WCAP-14572
Revision 1-NP-A
Supplement 1

Westinghouse Structural Reliability and Risk Assessment (SRRA) Model for Piping Risk Informed Inservice Inspection

SUBJECT: SAFETY EVALUATION OF TOPICAL REPORT WCAP-14572, REVISION 1,
"WESTINGHOUSE OWNERS GROUP APPLICATION OF RISK-INFORMED
METHODS TO PIPING INSERVICE INSPECTION TOPICAL REPORT"

Figure 4-2 Comparison of SRRA Model With Flow Assisted Corrosion Data

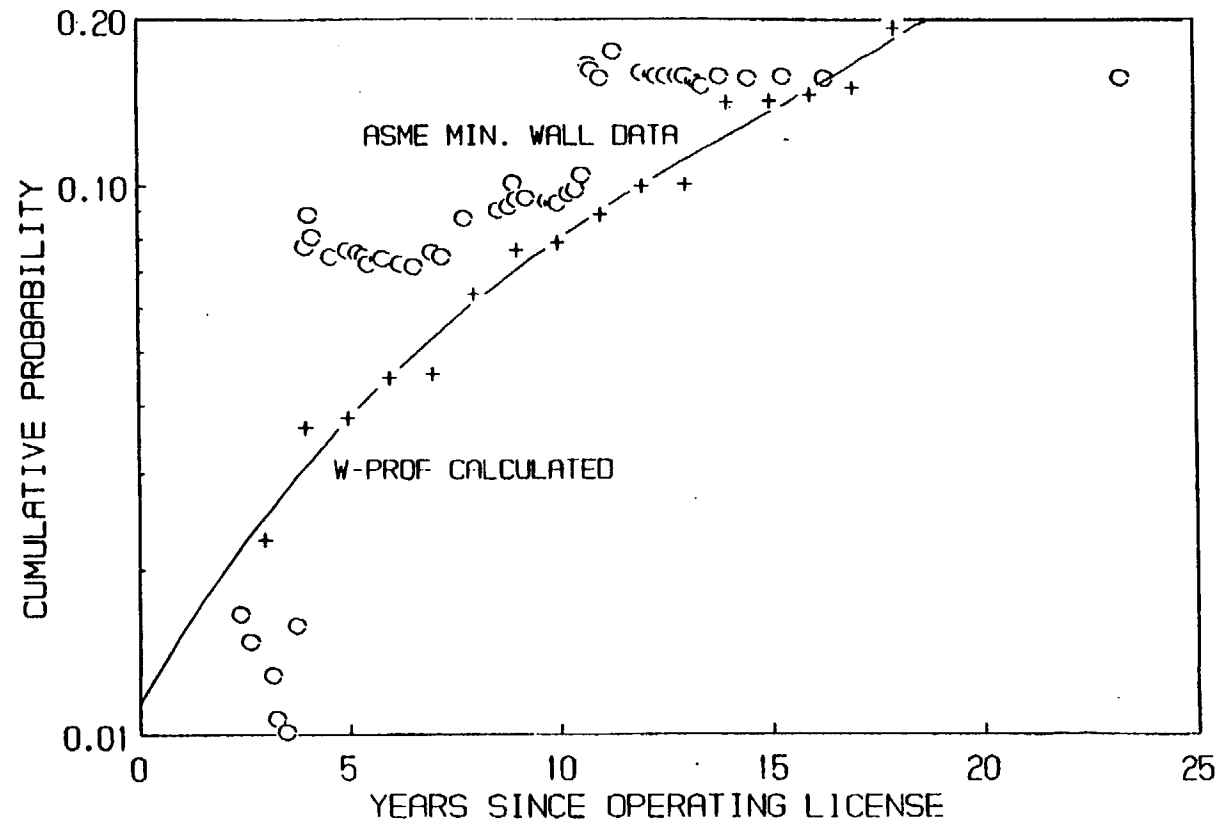
Figure 4-2 of WCAP-14572, Revision 1, Supplement 1, graphically compares SRRA model predictions with industry plant data relative to the probability of violating minimum wall thickness criteria because of flow-accelerated corrosion wastage. The staff had expressed a concern (Ref. 9) that the graph indicates that the SRRA model tends to over-predict the failure probability early in plant life and to under predict later in life. In the public meeting on September 22, 1998 [item 7 (a), Ref. 8], Westinghouse explained that the minor over-prediction early in life is attributable to lower plant startup capacity factors (fraction of time at full power and flow), while the minor under-prediction later in life is attributable to higher capacity factors during this more mature period of plant operation. The staff finds this response acceptable since the industry observed failure rates due to wastage are within a factor of 2 to 3 of the SRRA calculated values even though the calculation was based upon data averaged values of pipe size and wall thickness.
